# SAFETY RECALL

Communication #: T-23-03

Model Year(s): 2020-2023

## **SUBJECT: REVERSE CAMERA**

## T-23-03-A RIDE COMMAND INSPECTION

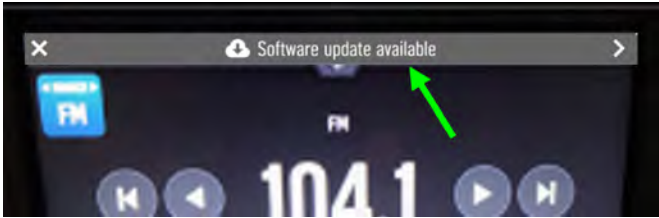
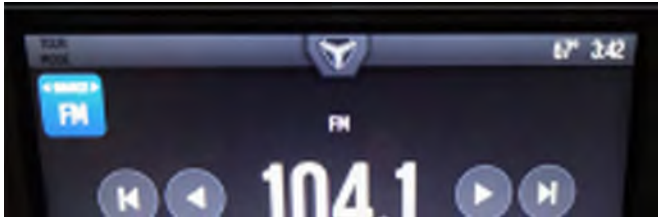
1. Inspect the vehicle to determine if it is equipped with Ride Command.

IS THE VEHICLE EQUIPPED WITH RIDE COMMAND?	
<b>Yes</b>	Proceed to <b>page 6</b> .
<b>No</b>	Submit a Service Bulletin Warranty Claim for T-23-03-A.
